DESIGN REVIEW III OREGON SQUARE

November 5, 2015

AMERICAN
ASSETS
TRUST

CAMPUS COMMENTS TO ADDRESS - POST DR II

CURRENT - DR3 PLAZA DESIGN

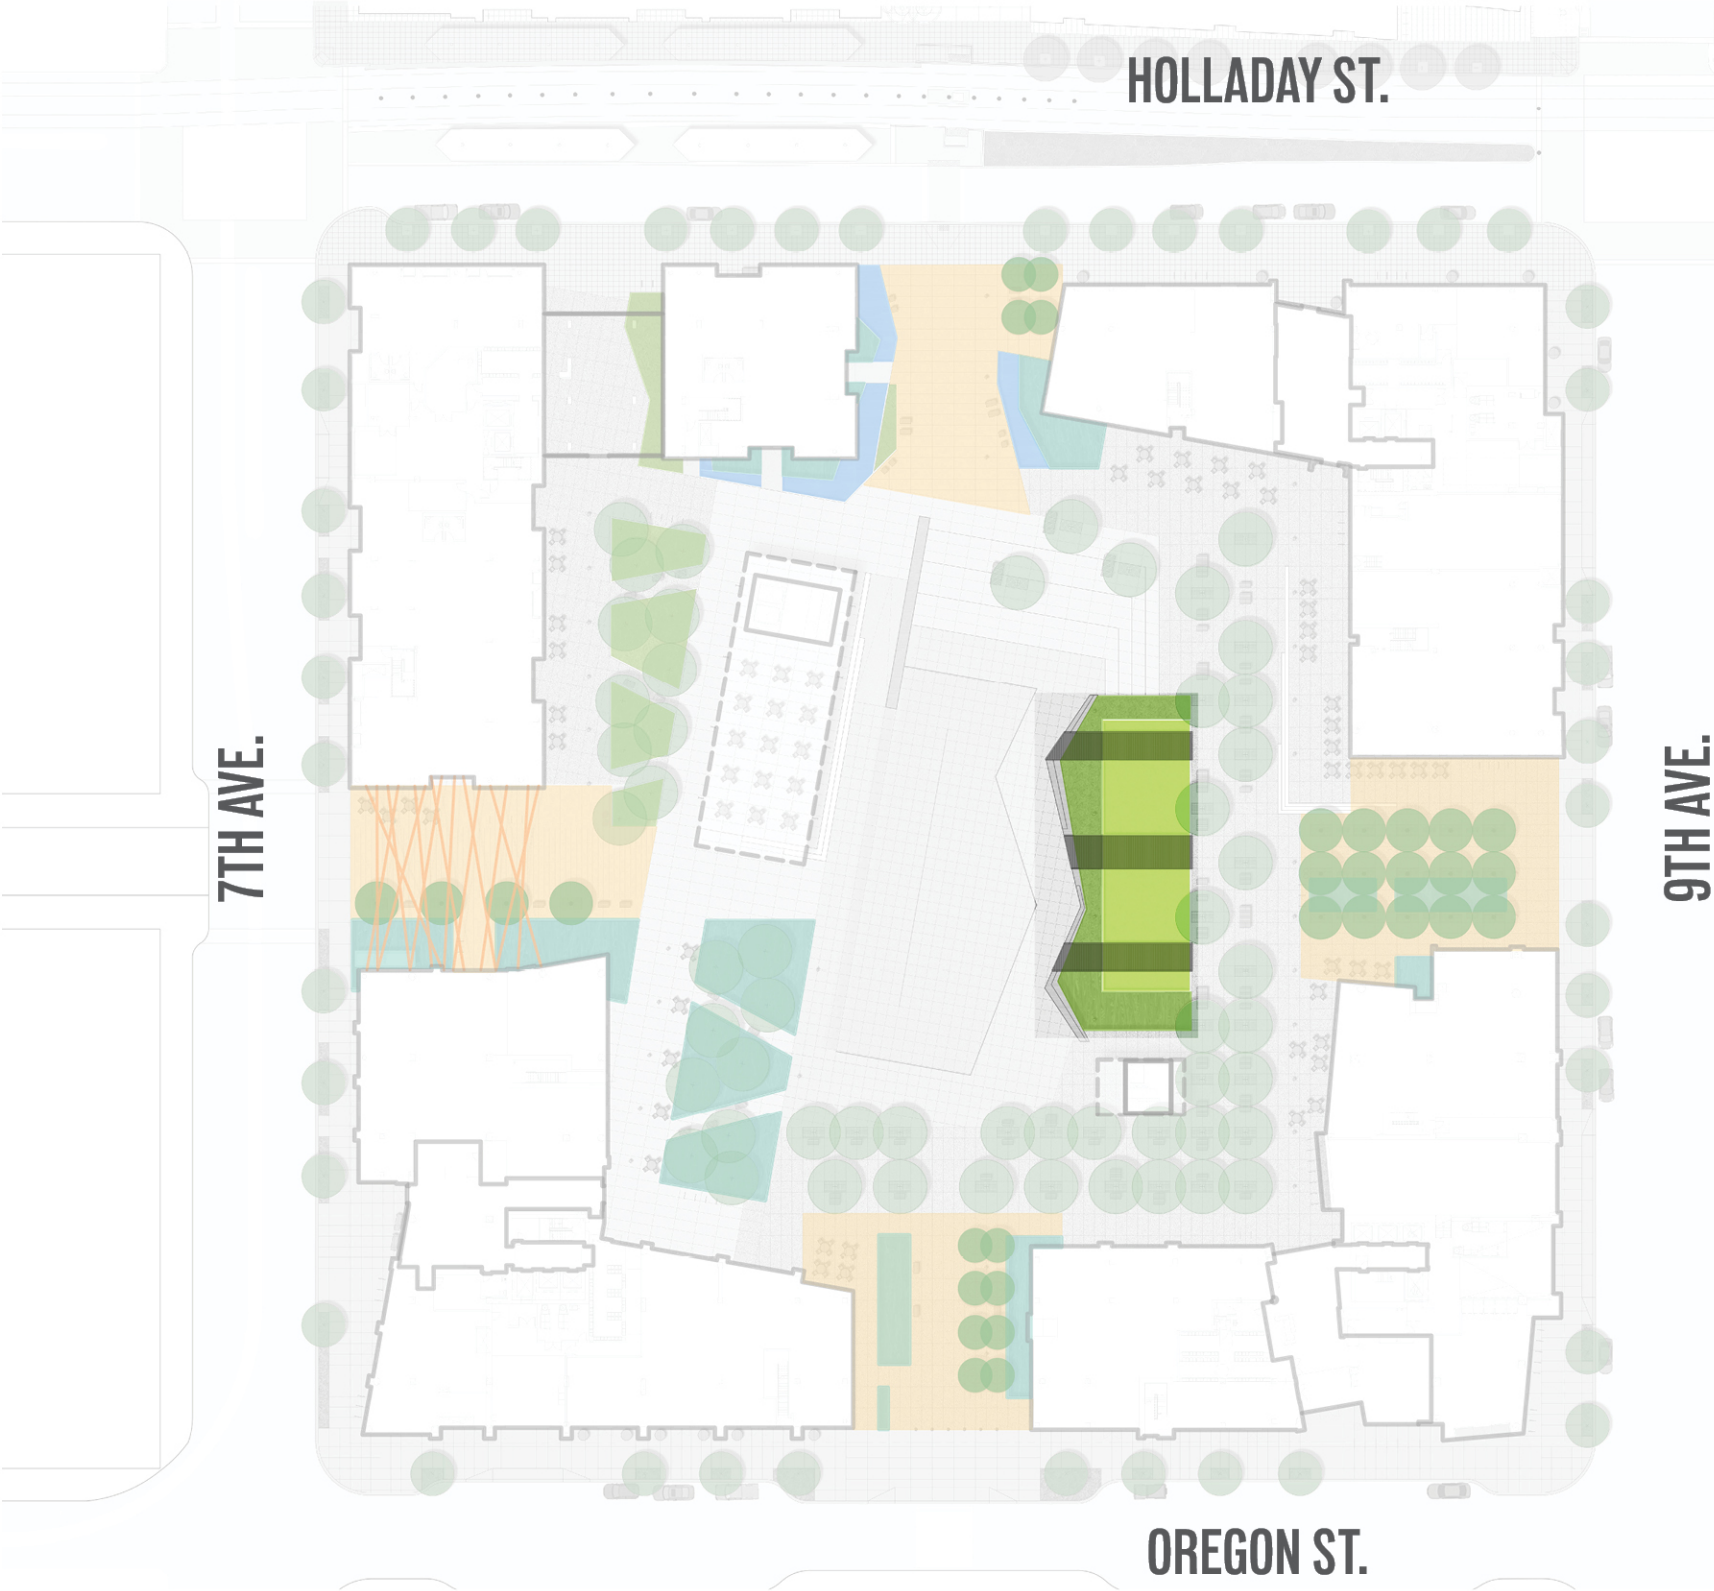
BRIDGES STILL FEEL TEMPORARY AND UNRESOLVED. DIFFERENTIATION OF BRIDGE MATERIAL AND PLAZA SURFACE IS GOOD BUT SHOULD NOT BE CONCRETE OR METAL GRATE. SHOULD ALSO WIDEN ONE TO 12'-0".

GBD: The design of these bridges over NORM have been updated; two of these bridges will be 10'-0" wide, and one bridge will be 12'-0" wide. The materiality of these bridges will be presented as a special finish and color concrete which will be flush with the surrounding surface. The team looked at wood as an alternate material, but concerns of slip resistance are an issue in a public space.

MOBILE SEATING - OREGON SQUARE

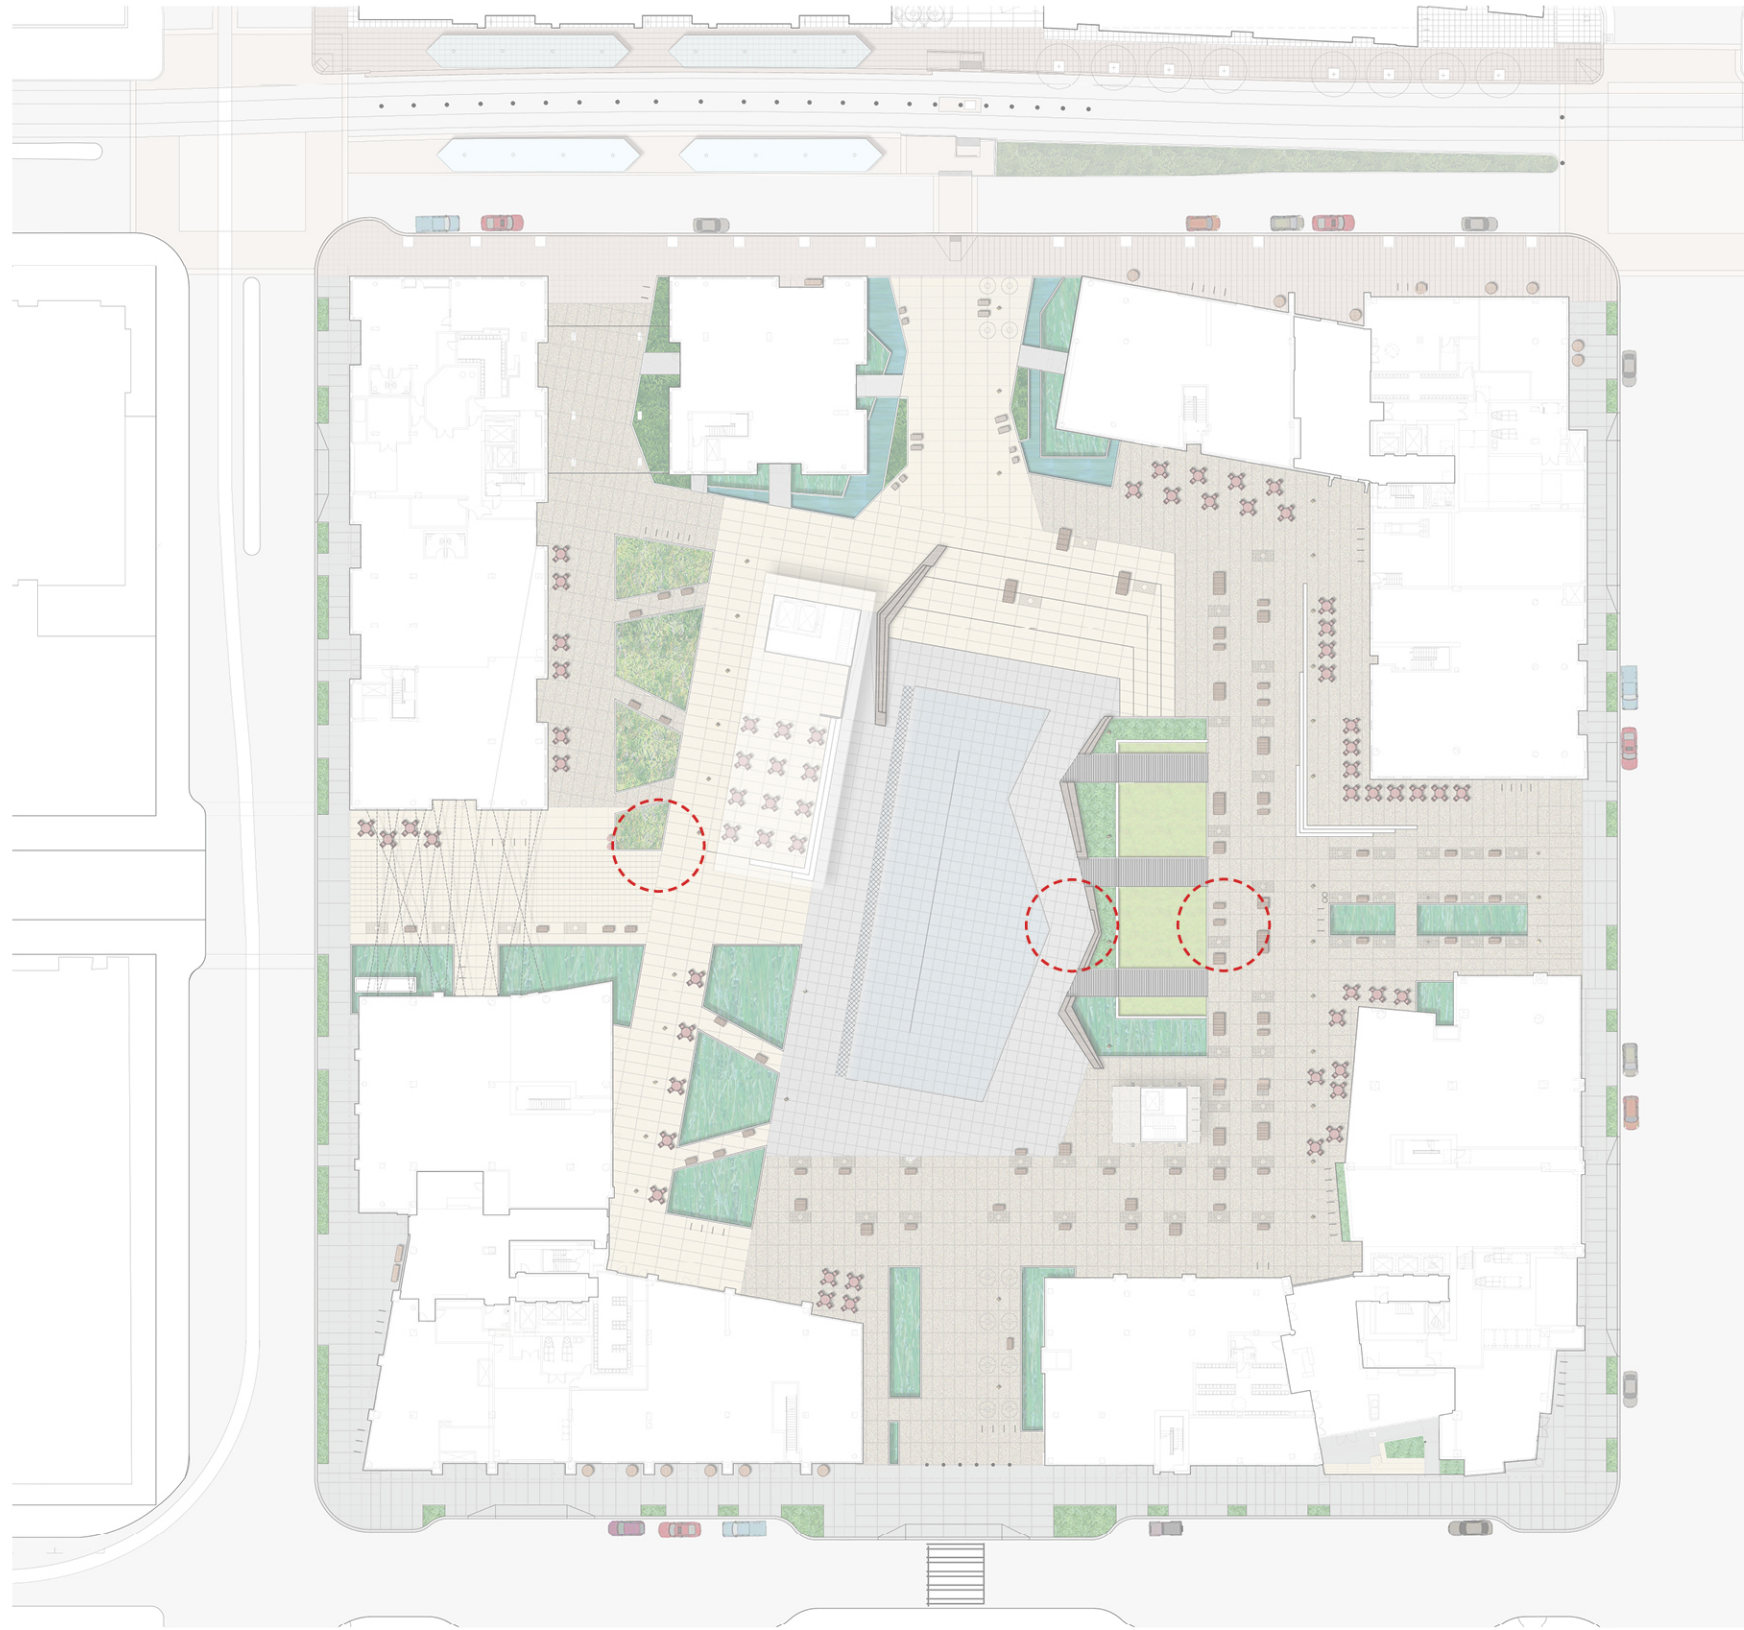
CONTINUE TO CONSIDER THE ADDITION OF MOBILE SEATING

GBD: Retail will be encouraged to provide cafe seating, and the owner will include a stock of mobile seating that they will use as needed, but we find it difficult to condition approval on this. The owner will provide mobile seating and will manage it with required staff to keep the plaza active and inviting.

SE CORNER AND ENTRY

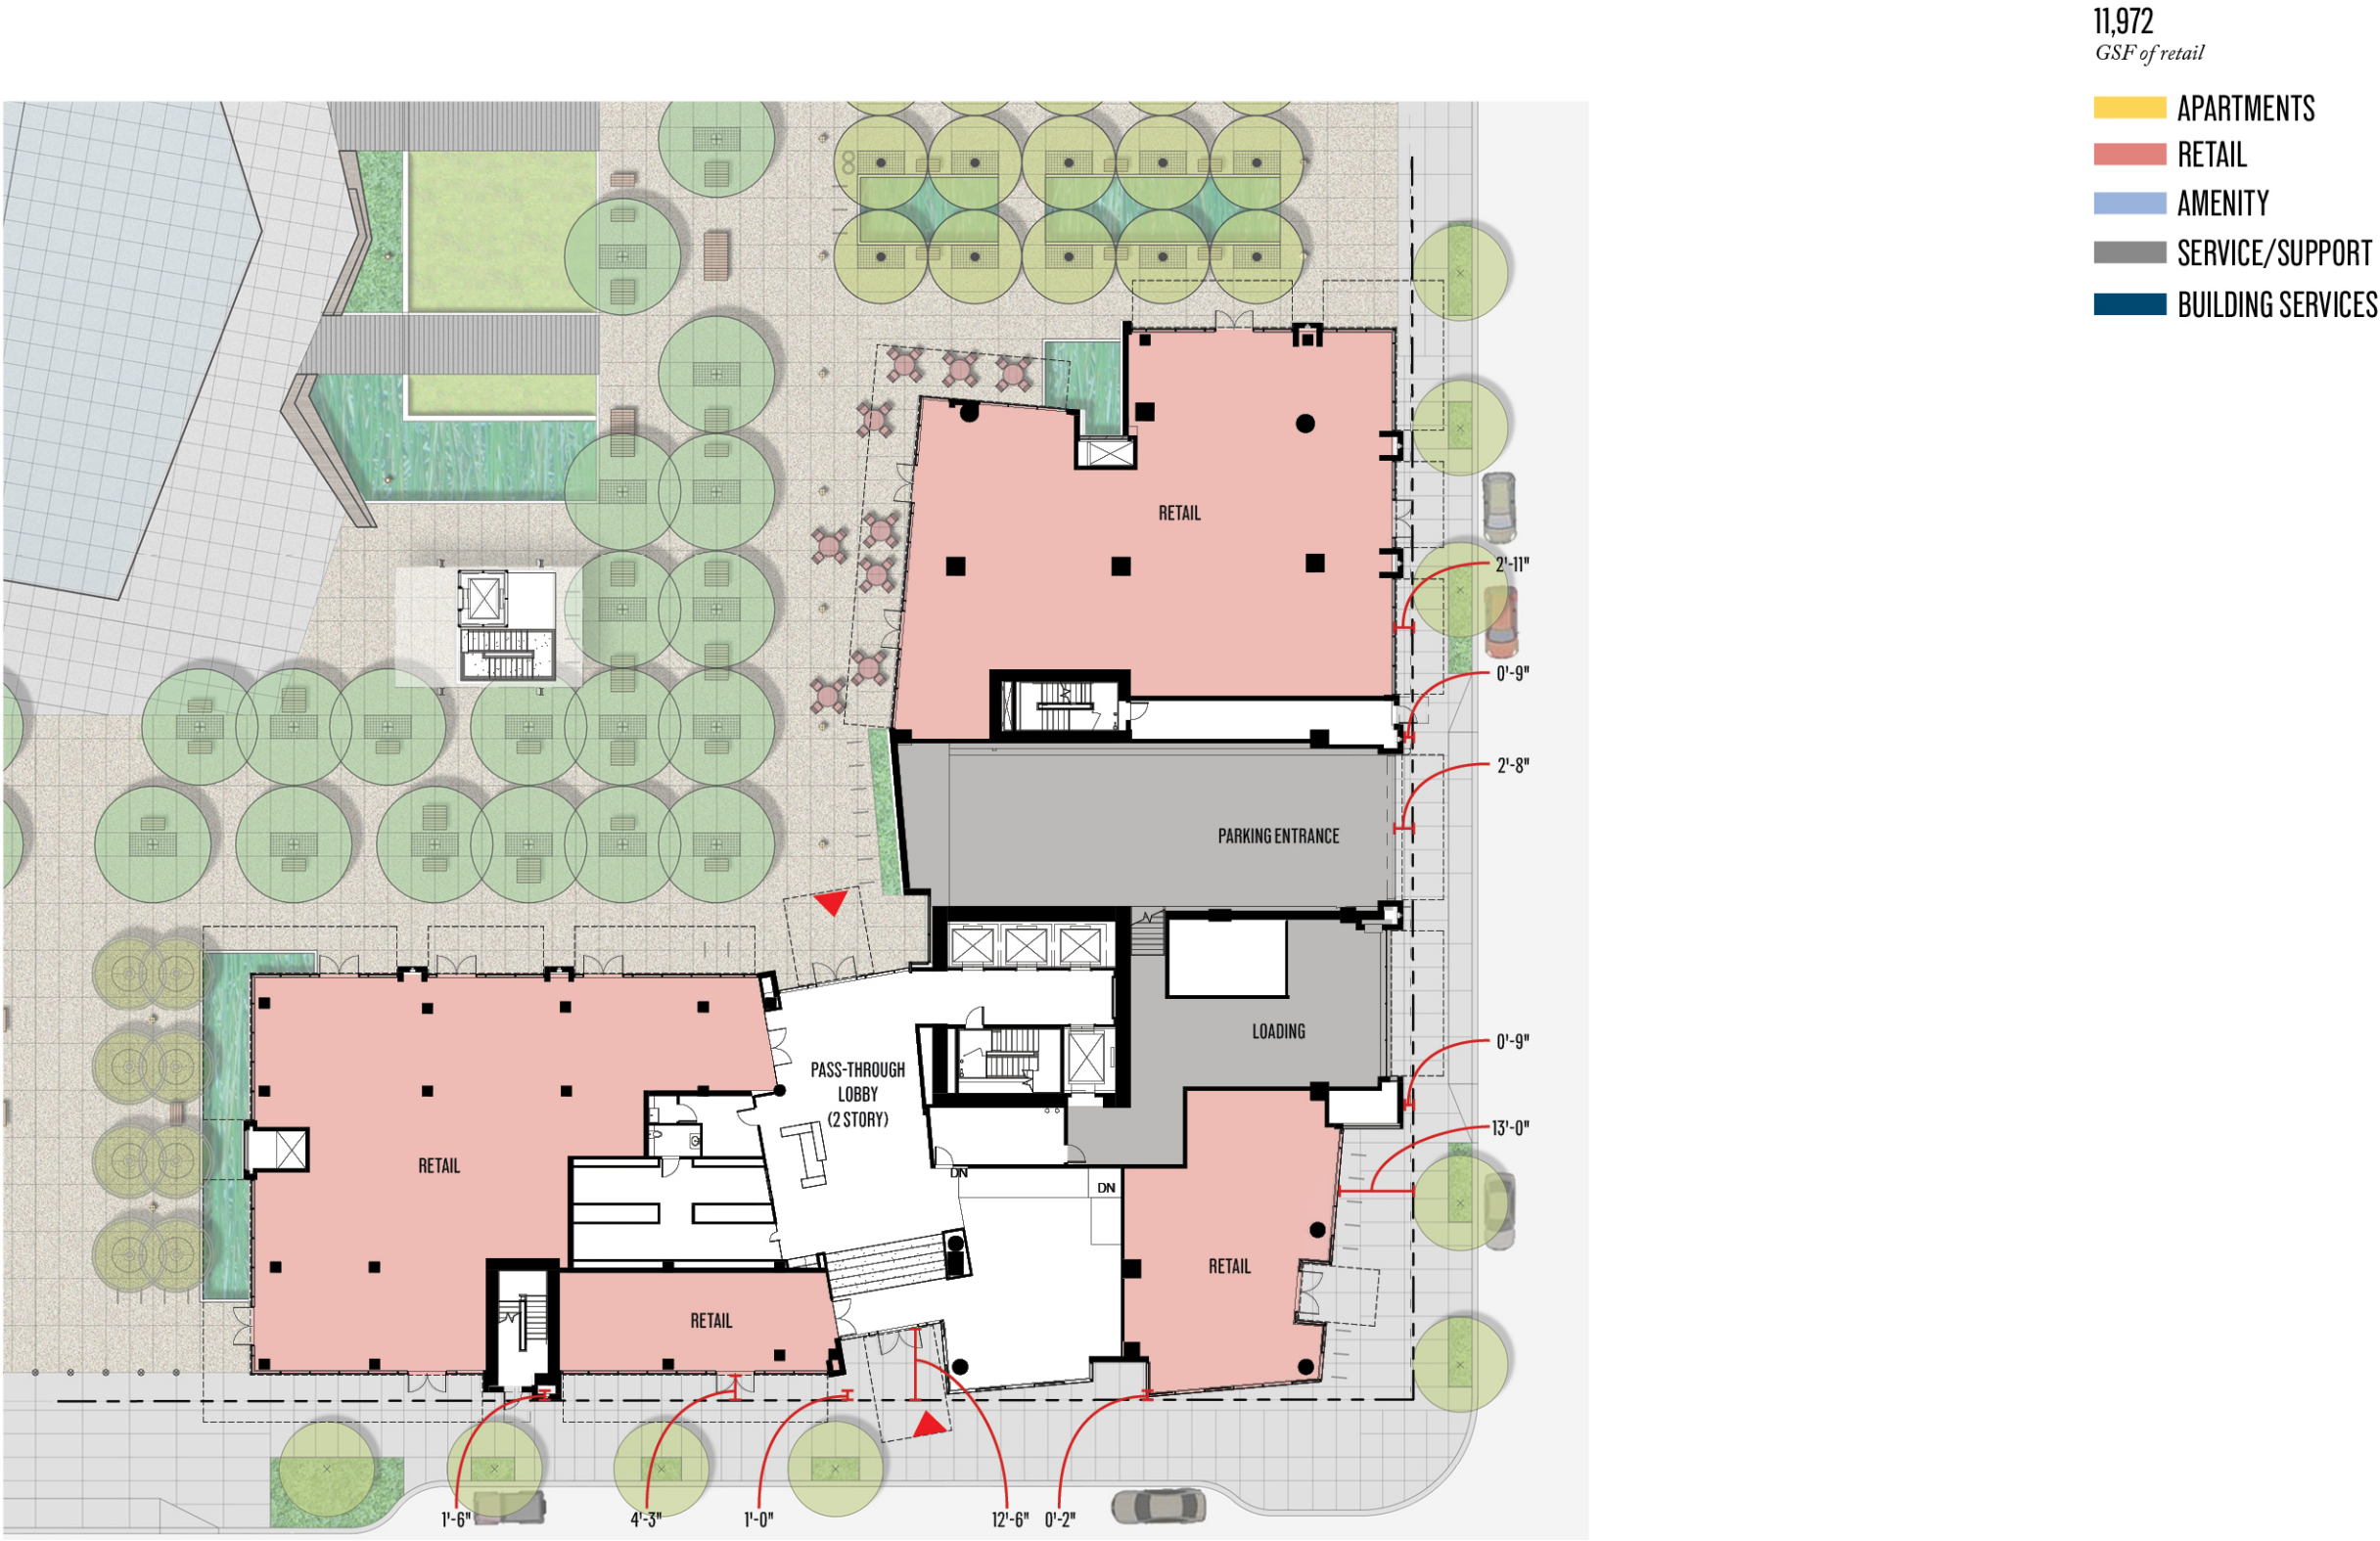
ONE MORE PASS IS NEED ON HOW THE PODIUM EMETS THE TOWER AT THE SOUTHEAST CORNER.

GBD: The precast concrete of the podiums has been changed to glass in order that both podiums could have more of a glassy reading and be more similar to the tower. The southeast corner comes down to the ground as a contrasting entry element to the main lobby.
